FIELD INSTALLATION INSTRUCTIONS

SOLENOID REPLACEMENT

FI-53

Figure 1.

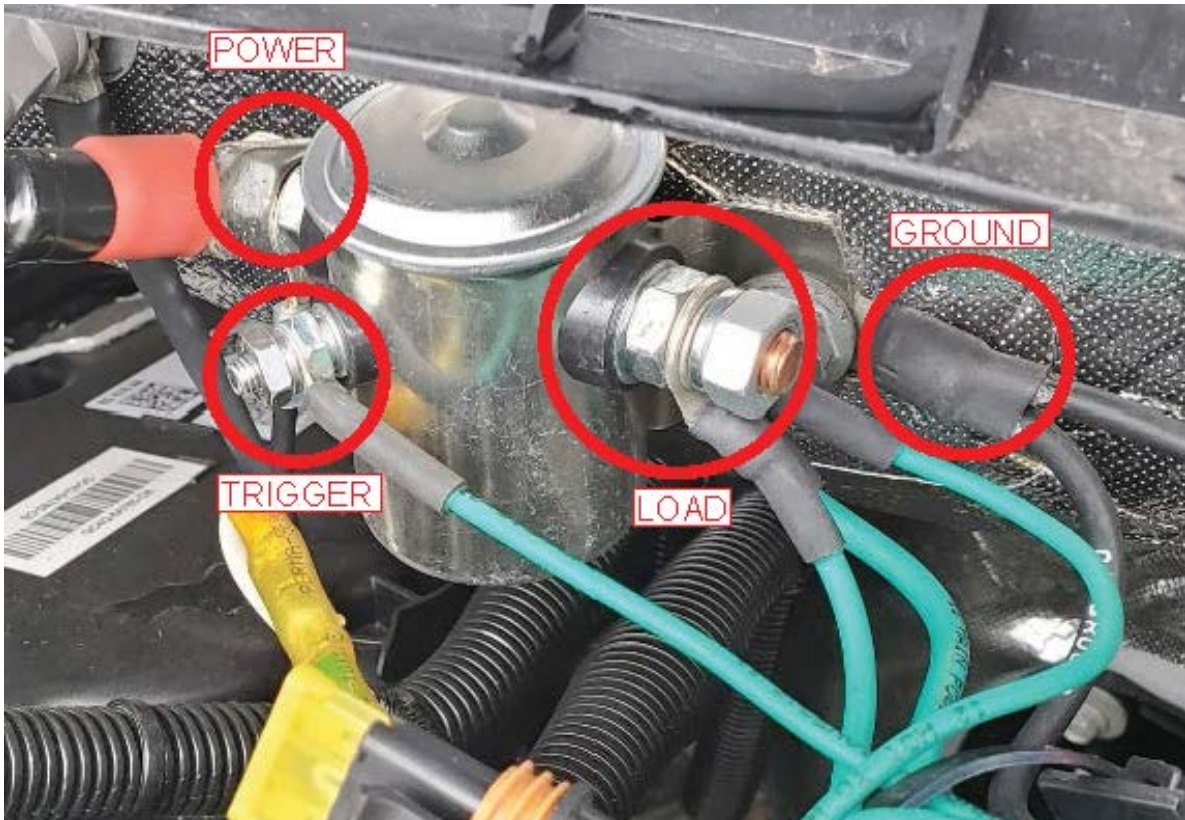
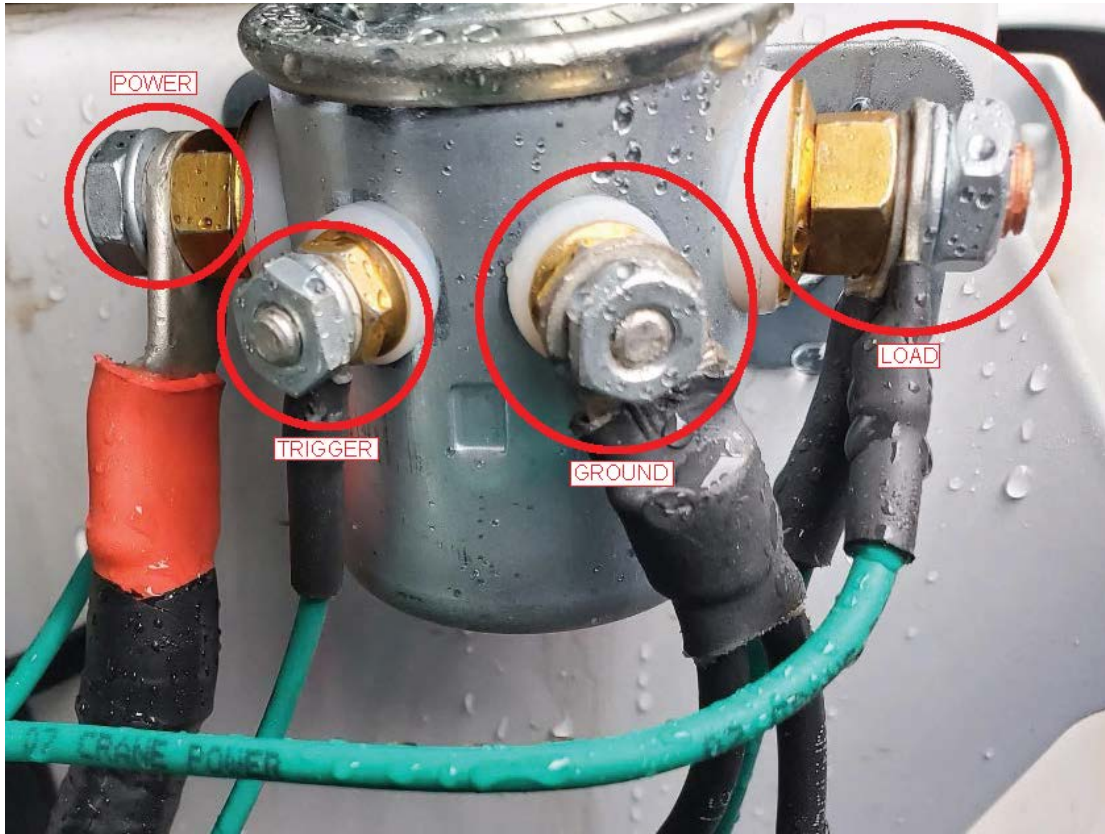
1. Disconnect the positive (+) and negative (-) wires from the OEM vehicle battery.
2. Disconnect the POWER, TRIGGER, and LOAD wires from the 3-post solenoid shown in Figure 1 below.

3. Unbolt the 3-post solenoid from its mounted location and remove the GROUND wires from mounting bolt when applicable. (Set the hardware aside for future use).

NOTE: The 3-post solenoid is “case grounded”, which is why the GROUND wires are not connected to a post on the solenoid.

DO NOT reinstall the ground wires to the mounting bolt as shown in the Figure 1. The new solenoid has a dedicated ground post.

4. Remove ring terminal connection from the existing ground wire/wires and replace it with a new ring terminal sized for a #10 post.
5. Install the new 4-post solenoid in the same location as the existing 3-post solenoid.

6. Reconnect the existing POWER, TRIGGER, LOAD, and GROUND wires in the locations shown in Figure 2 below.

NOTE¹: If no ground wire was used on the 3-post solenoid, one must be added.

NOTE²: Solenoids may have varying quantities of wires on each post based on application. Be sure to reconnect all wires to their original locations.
